## Public Input No. 234-NFPA 13-2022 [ Global Input ]

## Public Input No. 3-NFPA 13-2021 [ Global Input ]

## Public Input No. 468-NFPA 13-2022 [ New Section after 3.3.80 ]

## Public Input No. 520-NFPA 13-2022 [ Section No. 21.4.1.7.1 ]

FIGURE A.3.3.81 Example of Fire-Stopping at Intersection of Purlins and Girders

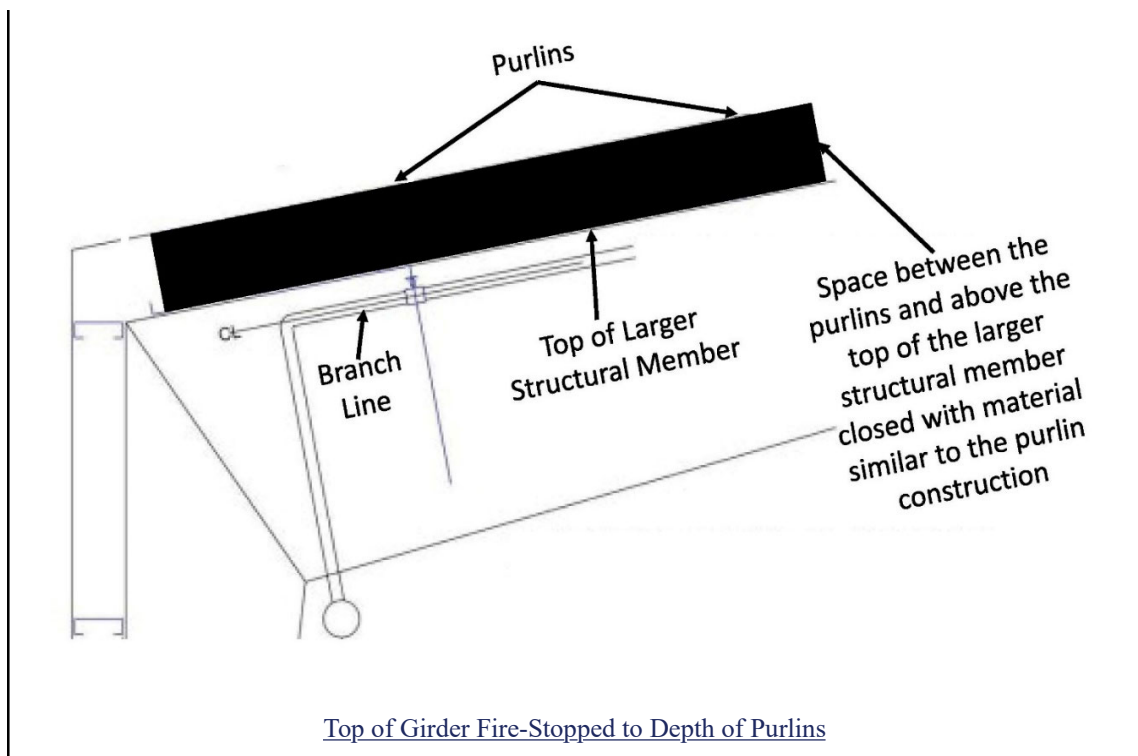
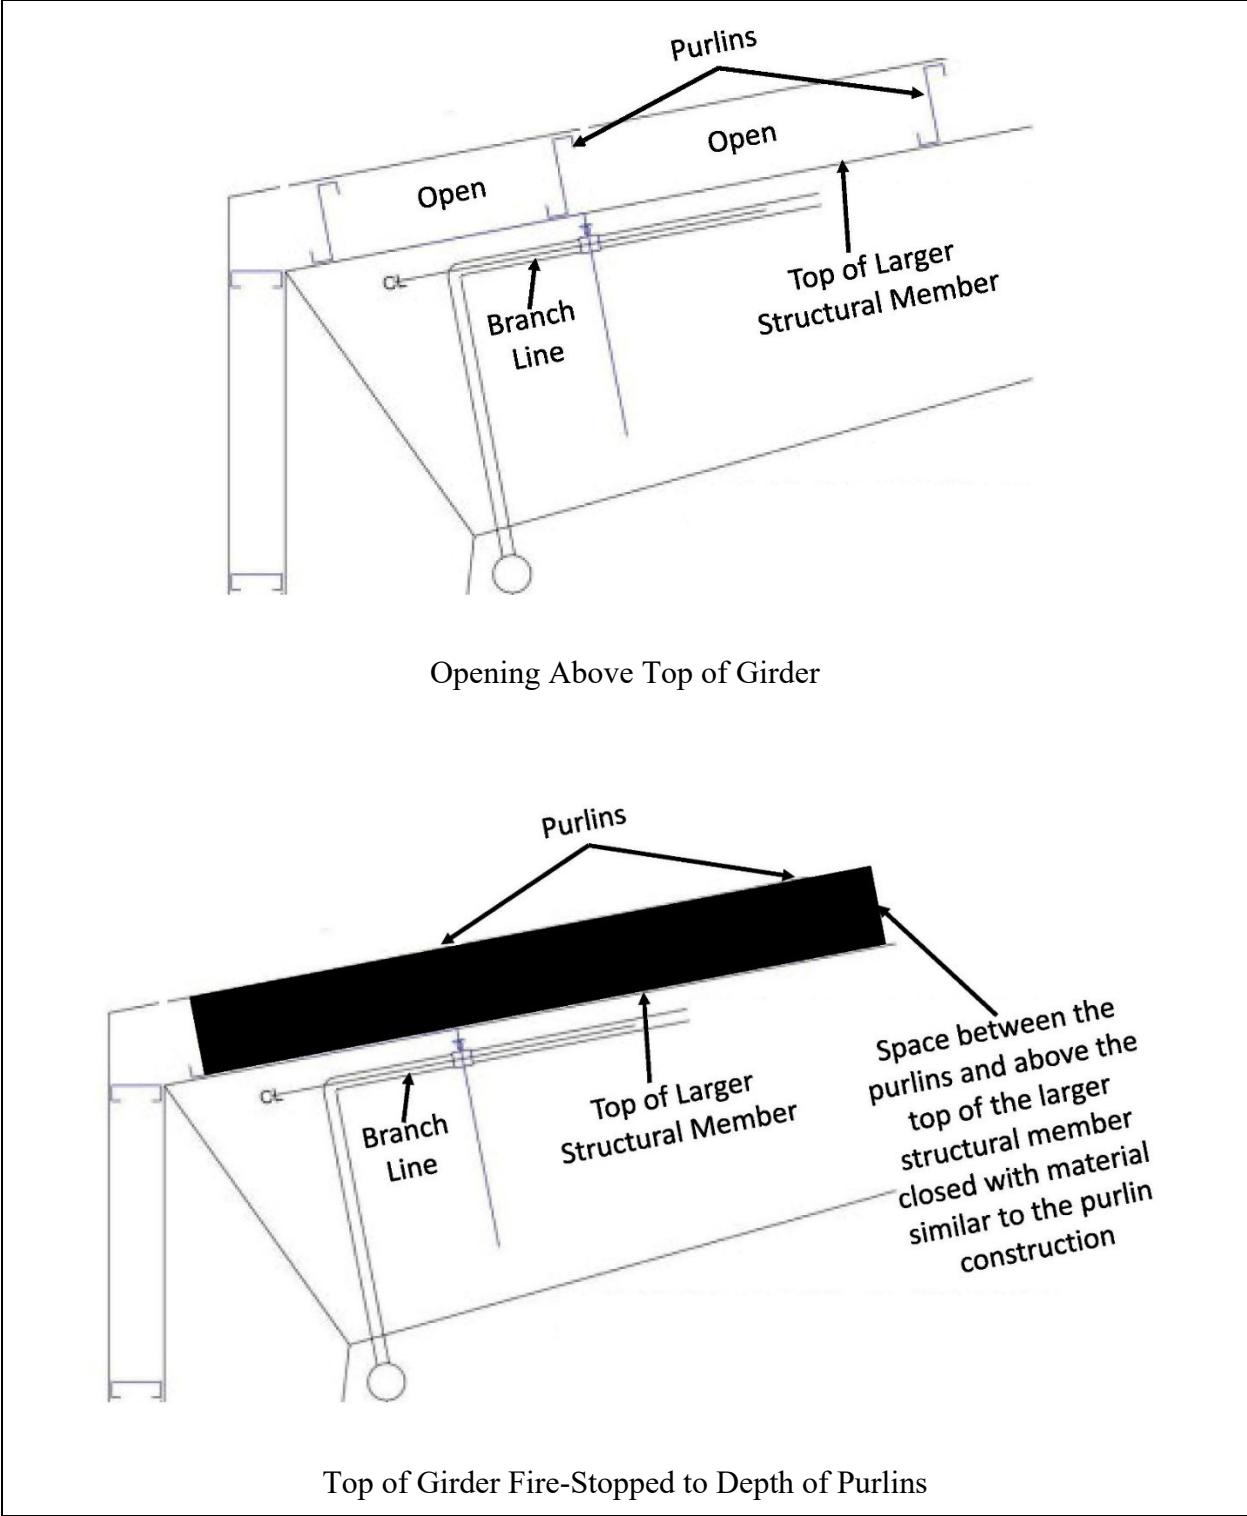
Substantiation: The term fire-stopped is used in various parts of the standard but is not currently defined. As a result, a definition for this term has been proposed with accompanying Annex language to help demonstrate the intent of fire-stopping.

**Figure 19.2.3.1.1 Density/Area Curves for the Evaluation or Modification of Existing Systems.**

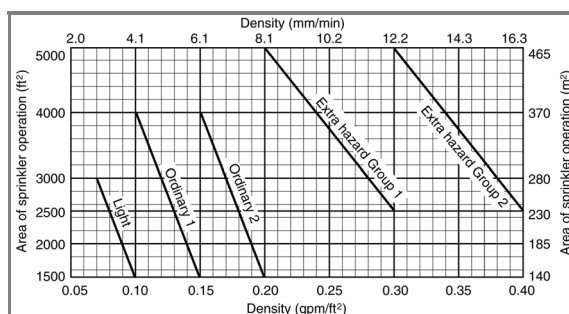
The requirements in Section 19.2.3.1.1(2) are specific to existing systems and are being deleted due to a proposal to relocate these requirements into Chapter 30. See the proposal for relocating this language along with Figure 19.2.3.1.1 to Section 30.4.3.2. With the removal of references to existing systems in this section, the term “new” relative to systems can be removed from 19.2.3.1.1(1).

**Figure 25.3.1.3 CMDA Ceiling-Level Sprinkler Characteristics in Combination with In-Rack Sprinklers.**

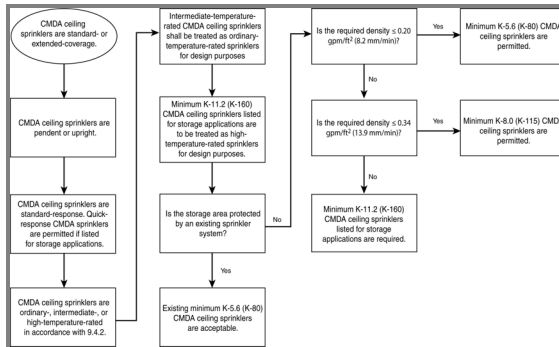
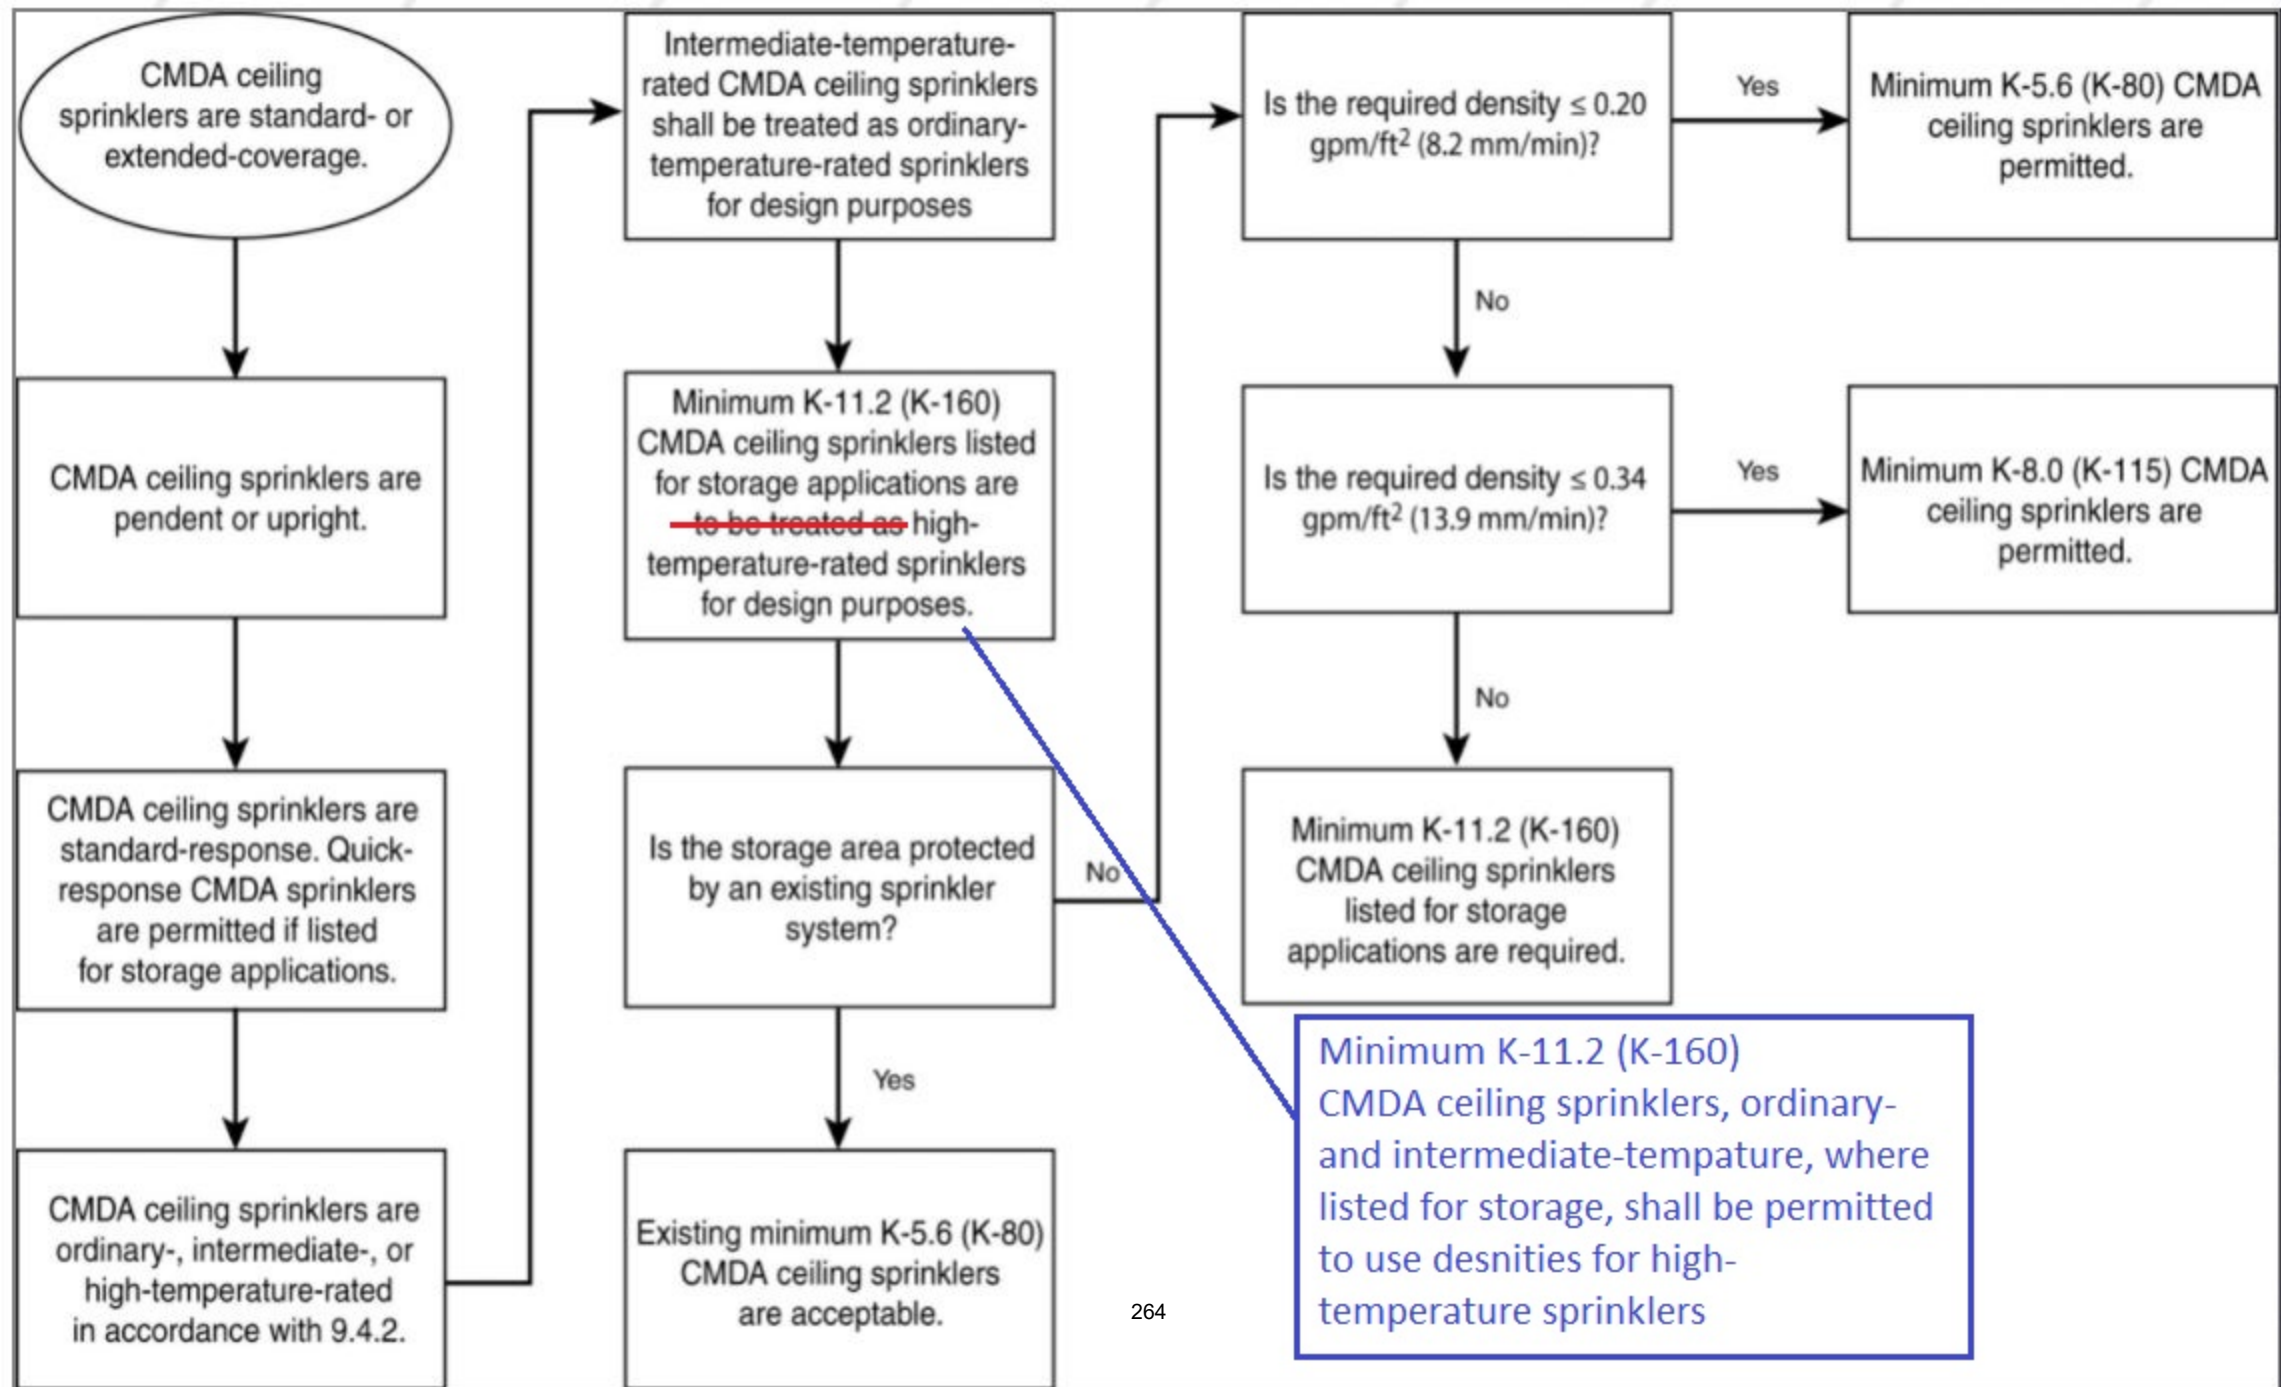
The new Figure 25.3.1.3 is within 25.3.1 (general to all IRAS with CMDA) and has a section stating any K-11.2 sprinklers listed for storage 'are to be' treated as high-temperature for design purposes. Believe the term her is 'can be' versus 'are to be'.

Note, section 25.3.2 is for rack storage up to 25 feet and the ceiling level densities located on Table 25.3.2.1.2.1(A)(a-d) have lower densities for high temperature sprinklers (no conflict here); However, section 25.3.3 is for rack storage over 25 feet in height and the numerous figures in this section have higher sprinkler densities for high temperature sprinklers and lower densities for ordinary-temperature sprinklers. Therefore, providing an ordinary temperature, K-11.2 sprinkler, would require using a higher than necessary density for rack storage over 25 feet when implementing the new Figure 25.3.1.3.

Figure 25.6.2.3.1(b) In-Rack Sprinkler Arrangements for Class I through Class IV and Cartoned Group A Plastic Commodities, Maximum 30 ft (9.1 m) Vertical Increments.

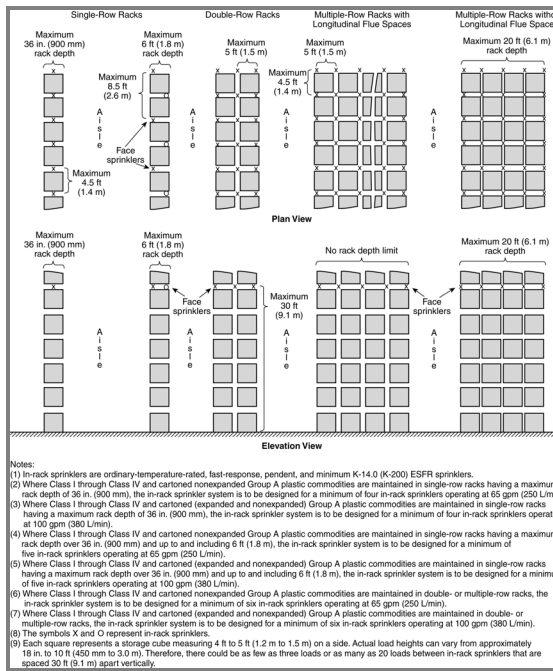
**Revise Figure 25.6.2.3.1(b) so that it matches the in-rack sprinkler arrangements shown in former Figures 25.8.2.4(d) and 25.8.2.4(f) from the 2019 Edition of NFPA 13.**

Figure 25.6.2.3.1(b) is the same drawing as Figure 25.6.2.3.1(c) and should have been a combination of Figures 25.8.2.4(d) and 25.8.2.4(f) from the 2019 Edition of NFPA 13.

**Figure 25.6.2.3.1(e) In-Rack Sprinkler Arrangements for Class I through Class IV and Cartoned Group A Plastic Commodities, Maximum 30 ft (9.1 m) Vertical Increments.**

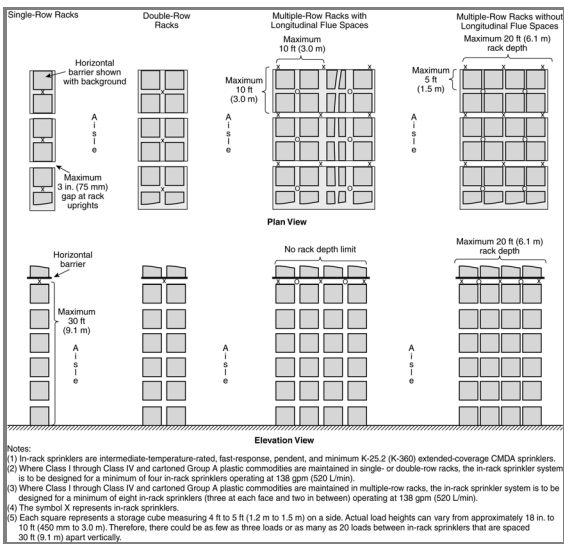
Add the wording "and O" to Figure 25.6.2.3.1(e) since the figure incorporate both "X" and "O" as in-rack sprinklers.

**Figure 25.6.2.3.1(f) In-Rack Sprinkler Arrangements for Class I through Class IV and Group A Plastic Commodities, Maximum 20 ft (6.1 m) Vertical Increments.**

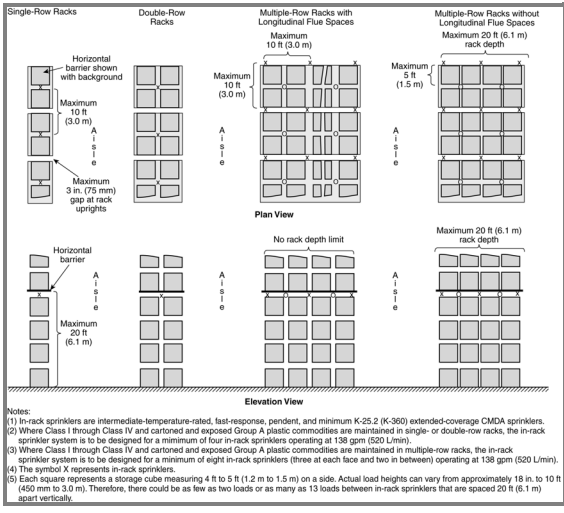
Add the wording "and O" to Figure 25.6.2.3.1(f) since the figure incorporate both "X" and "O" as in-rack sprinklers.
